CHANGE ORDER Relocate Traffic Controller

No. 5

PROJECT: **MEYERS ROAD EXTENSION**OWNER **CITY OF OREGON CITY**CONTRACTOR **CANBY EXCAVATING INC**

Contract Change Order No. 5

REVISIONS
DRAWING NUMBER: TS-10
SHEET OF

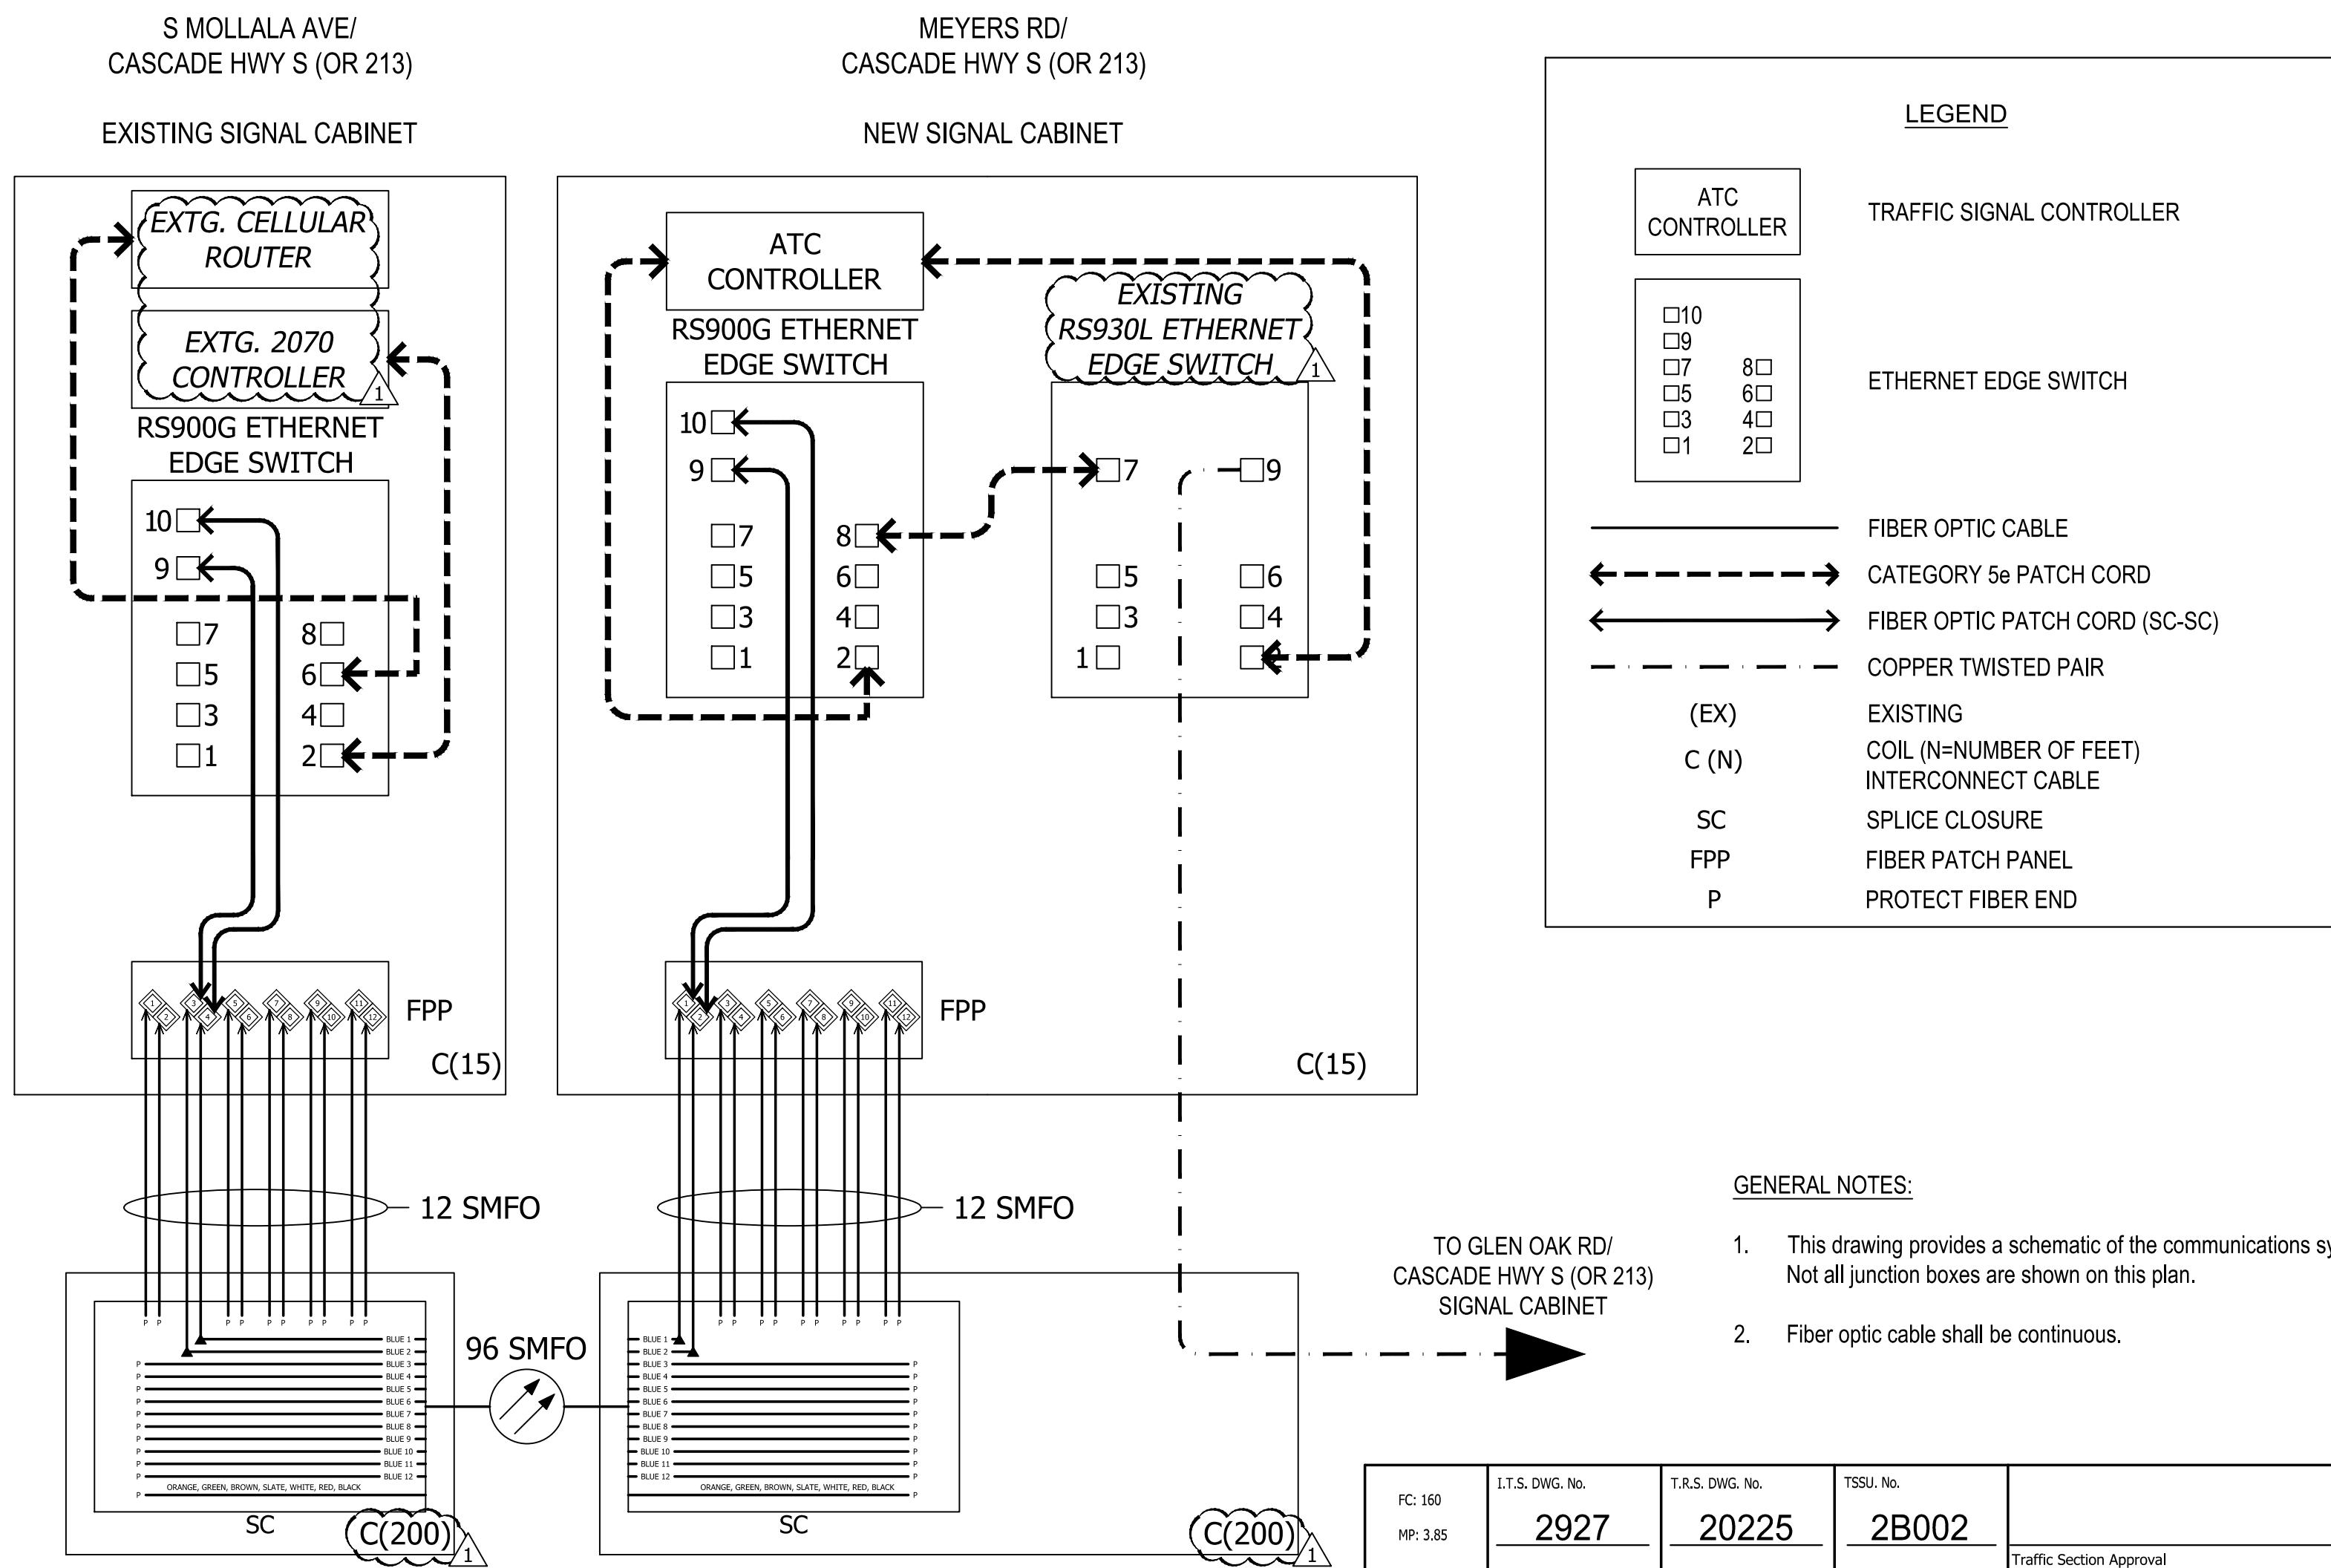
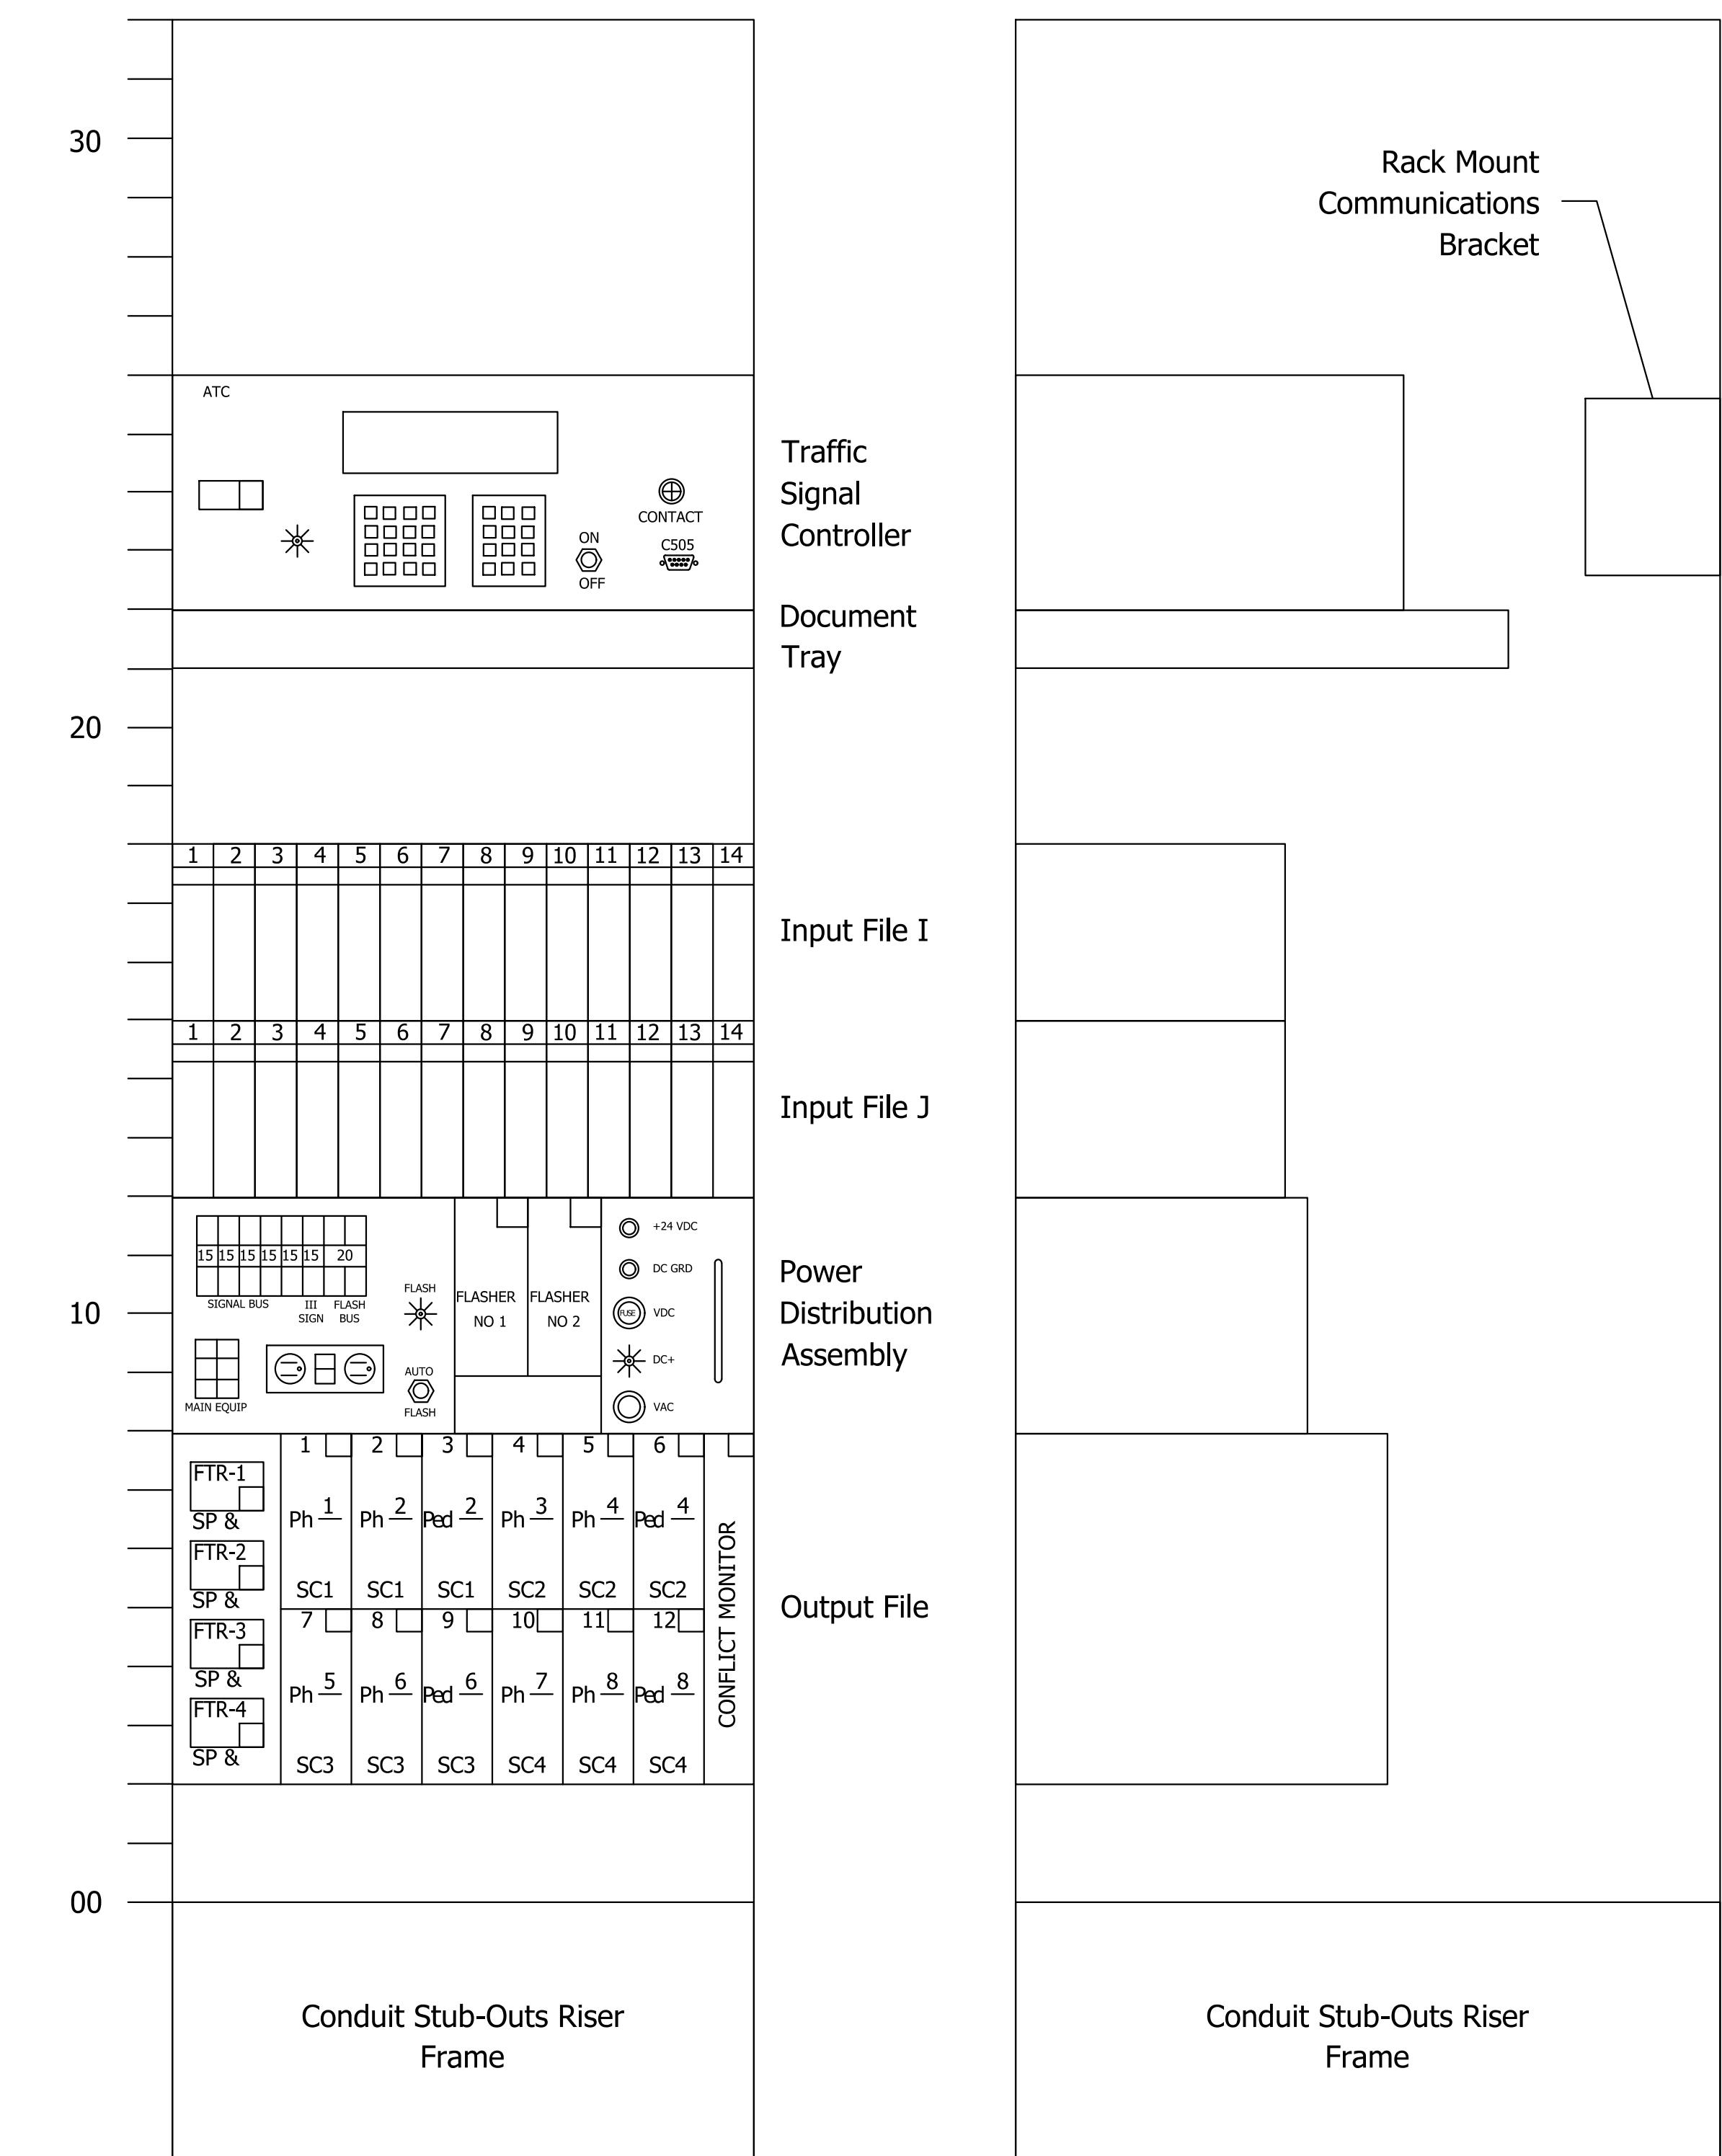
4005A: A plan update removed some equipment from our scope of work. This represents the credit for the equipment no longer required. (Please see Attachment No. 2 for revised Sheet TS-10)

- Cellular Router R1400, Power Cord, ODOT Comm Panel Fiber
- RSL910-H1-D-V1-V1-CO1, Power Cord, ODOT Comm Panel Fiber

4005A: It was identified after bidding that some of the equipment included in the plans for the ODOT Traffic Signal Cabinets was unnecessary per ODOT Region 1. A revision to Sheet TS-10 was made and provided to the Contractor with a request for a credit for the deleted equipment.

COMMUNICATION COMPONENT SCHEDULE			
LOCATION:	COMMUNICATIONS COMPONENTS	QUANTITY	OPTIC CONNECTION(S) TYPE
S MOLALLA AVE / CASCADE HWY S (OR 213)	A) ETHERNET EDGE SWITCH RS900G* SIEMENS PART NO. 6GK6090-0GS23-0BA1-Z A05	1	-
	B) SIX-FOOT POWER CABLE WITHOUT LUGS (BARE-WIRE) (FOR RUGGEDCOM RS900G SWITCH) SIEMENS PART NO. 6GK6000-8BB00-0AA0	1	-
	C) EXISTING CELLULAR ROUTER PART NO. R1400-3-B-1-A03-C00-D00-E00-F01-00	1	-
	D) INDUSTRIAL ETHERNET CABLE	1	-
	E) FIBER PATCH PANEL	1	-
	F) FIBER OPTIC PATCH CORD	2	-
	REMOVED COMMUNICATIONS BRACKET

COMMUNICATION COMPONENT SCHEDULE			
LOCATION:	COMMUNICATIONS COMPONENTS	QUANTITY	OPTIC CONNECTION(S) TYPE
MEYERS RD/ CASCADE HWY S (OR 213)	A) ETHERNET EDGE SWITCH RS900G* SIEMENS PART NO. 6GK6090-0GS23-0BA1-Z A05	1	-
	B) EXISTING ETHERNET EDGE SWITCH RS930L SIEMENS PART NO. 6GK6093-0AD23-0BA0-Z A00+000	1	-
	C) SIX-FOOT POWER CABLE WITHOUT LUGS (BARE-WIRE) (FOR RUGGEDCOM RS900G SWITCH) SIEMENS PART NO. 6GK6000-8BB00-0AA0	2	-
	D) INDUSTRIAL ETHERNET CABLE	1	-
	E) FIBER PATCH PANEL	1	-
	F) FIBER OPTIC PATCH CORD	2	-
	REMOVED COMMUNICATIONS BRACKET

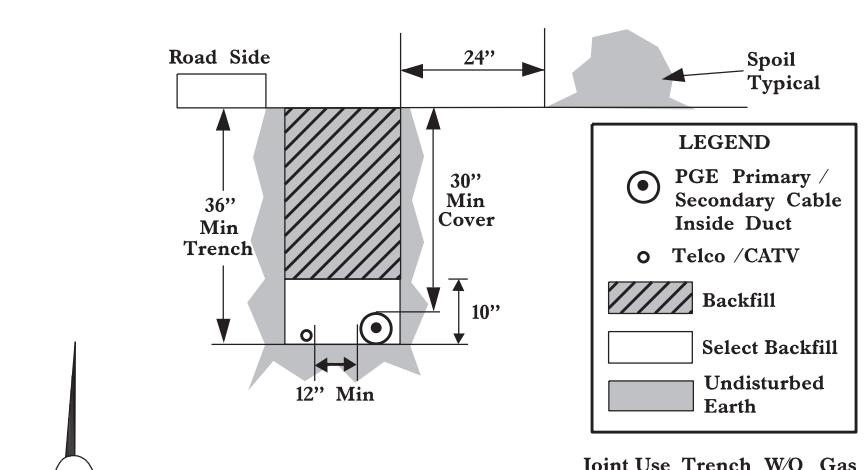
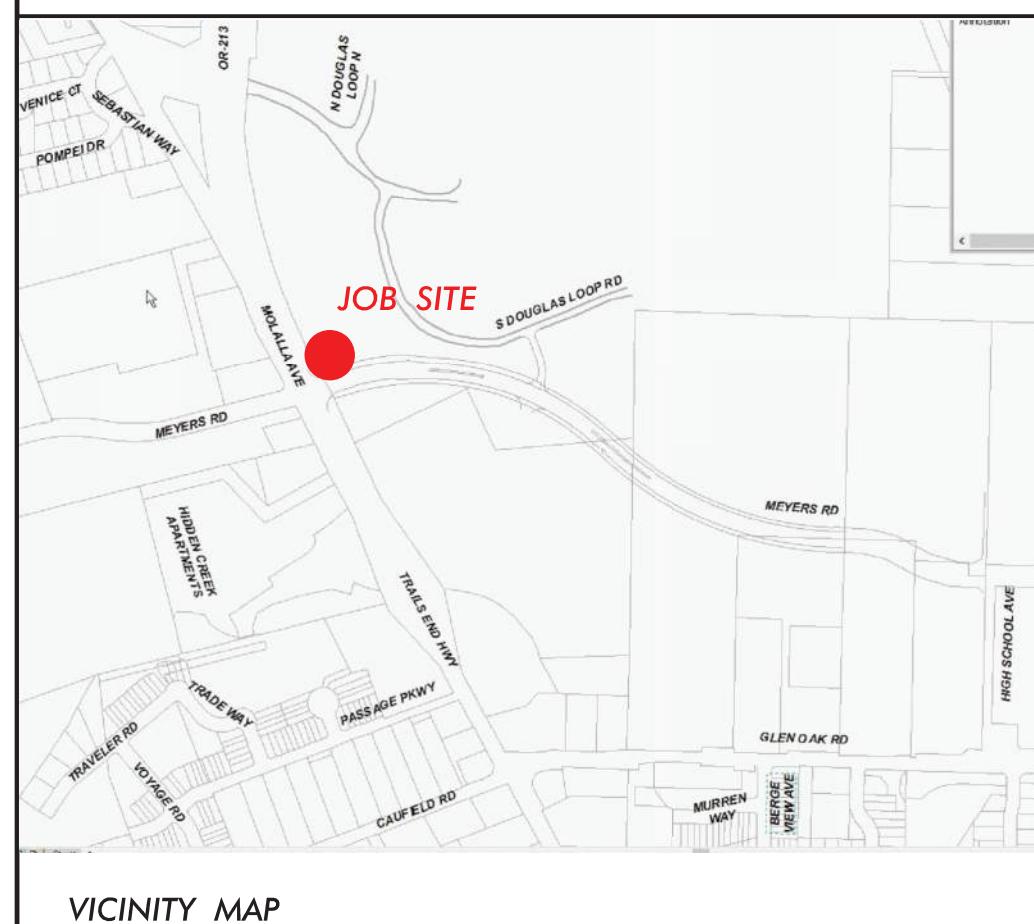
4005B: This change order compensates the contractor for the power service connection for the traffic signal as required by PGE. (see Attachment No. 3, revised sheets TS-3)

- Potholing w/traffic control
- Demo one or two sidewalk panels
- Approximately 130 feet of drilling under Highway 213
- Furnish and install 444 PGE Padmount Vault
- Install conduit as shown on drawings
- Restore sidewalk panels

4005B: The electrical service connection for the traffic signal was not included in the contract at the time of bid. It was not included in the bid package because PGE did not have their design completed at the time of bid. The revised construction drawings were provided to the Contractor and a price proposal was requested for the additional work. Upon receipt of the price proposal, it was reviewed by the Engineer and deemed acceptable.
